29 Brighton Street, Richmond

Attachment 4 - PLN13/1039 - 29 Brighton Street Richmond - Heritage advice original application

Heritage Advice on Amendment

Application No.: PLN13/1039.01

Above: Annotated sightline drawing from the opposite side of Brighton Street

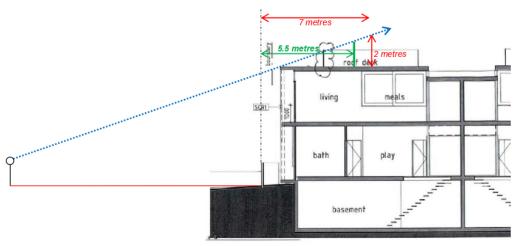
The proposed front setback for the western terrace is 3.6 metres from the front title boundary; 1.7 metres from the northern boundary and 2 metres from the southern boundary. Sightline diagrams show that the setback from the front of the property is not sufficient enough to conceal objects more than 2m high from across Brighton Street. In order to achieve full concealment (at least from immediately across from the subject site), the roof terrace would have to be set back at least 7 metres from the front title boundary.

- That the setback of proposed roof terrace on the west facing townhouse must be increased to no less than 5.5 metres from the front title boundary;
- That the proposed roof terrace balustrading on the west facing townhouse must be modified to be at least 1.7 metres high and constructed of a solid material finished in a grey colouring or similar.

Attachment 5 - PLN13/1039.01 - 29 Brighton Street Richmond - Amendment Plans

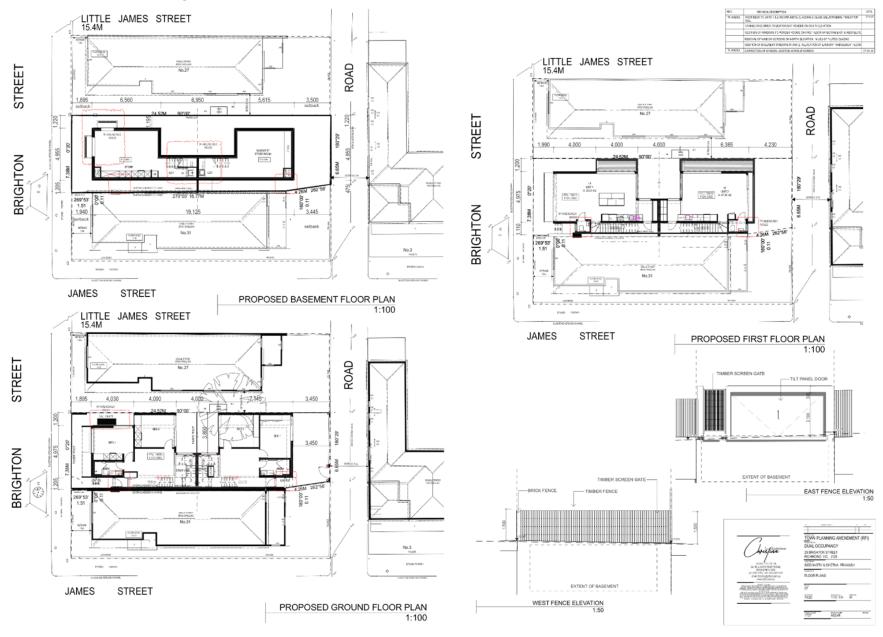
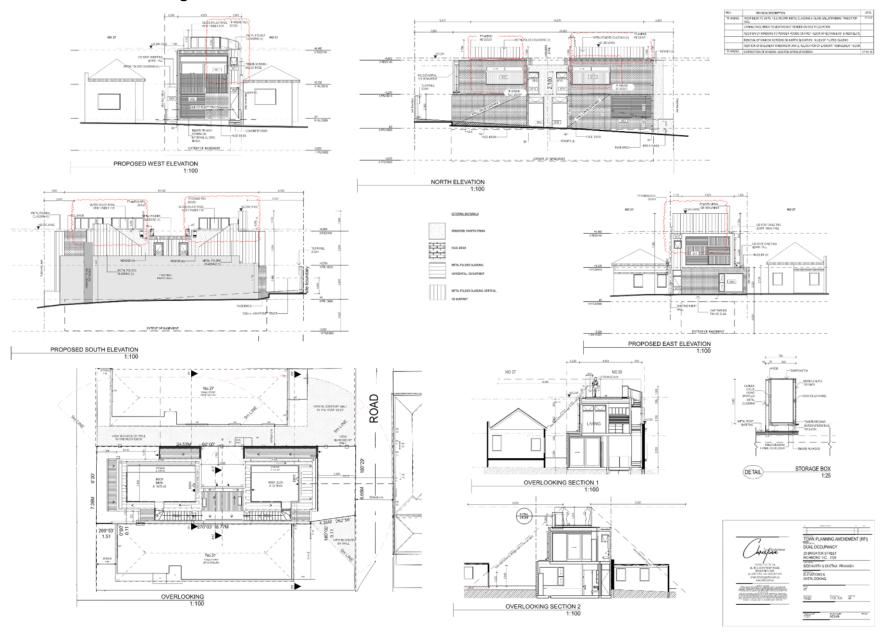
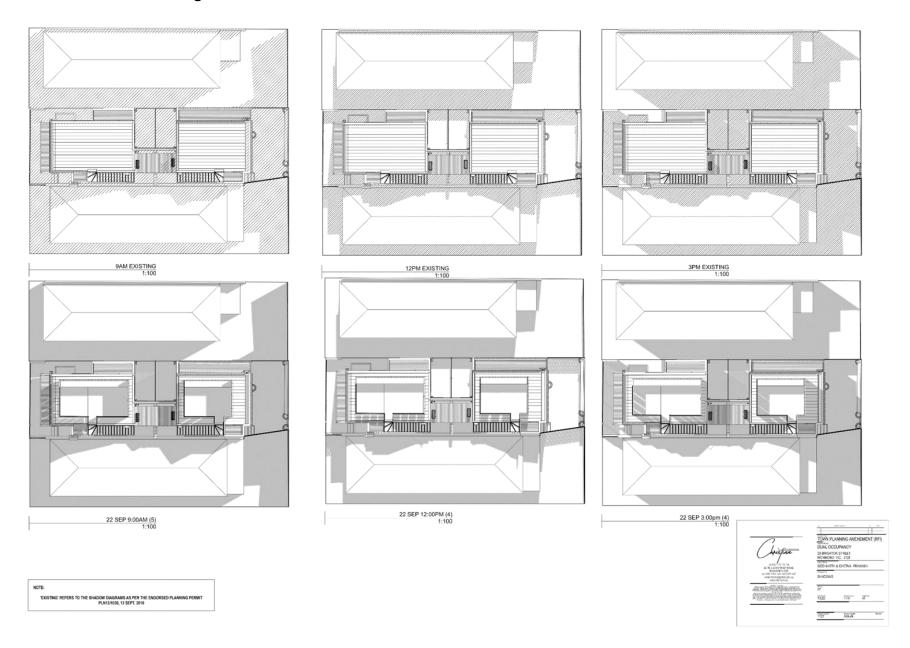
The proposal comprises the construction of a roof deck and associated stairs for both dwellings. Each deck, which will be centrally-located on the roof of its dwelling, will have contemporary glass balustrading with timber top and metal cladding screening.

The front setback of the decks will be 2.8m from Brighton Street and the proposed decks will add about 1m to the maximum building height of the dwellings, which will now be approximately 8.5m.

The application of the sightline assessment tool (Clause 22.02-5.7.1) used in the previous heritage advice to determine the minimum of 5.5m setback for the roof terraces only considered the visibility from directly opposite the site. As the structure of the approved building has been constructed, it has become evident that the proposed roof decks will be openly visible from all directions along Brighton Street, both near and far. In this case, it is considered that the sightline tool is of limited usefulness for assessing the real visual impact of the proposed roof decks on the streetscape. Roof decks are specifically discouraged in the heritage policy and the proposed roof terraces will be clearly apparent.

The use of glass balustrading is specifically not supported by the policy and will allow clear visible of all items and activity on the roof deck.

As currently designed, the proposed roof decks shown in this application are not supported.

Suggested condition	Explanation
1.	That the proposed roof top terraces must be deleted.	Open upper level decks and glass balustrades are specifically discouraged in Clause 22.02-5.7.1
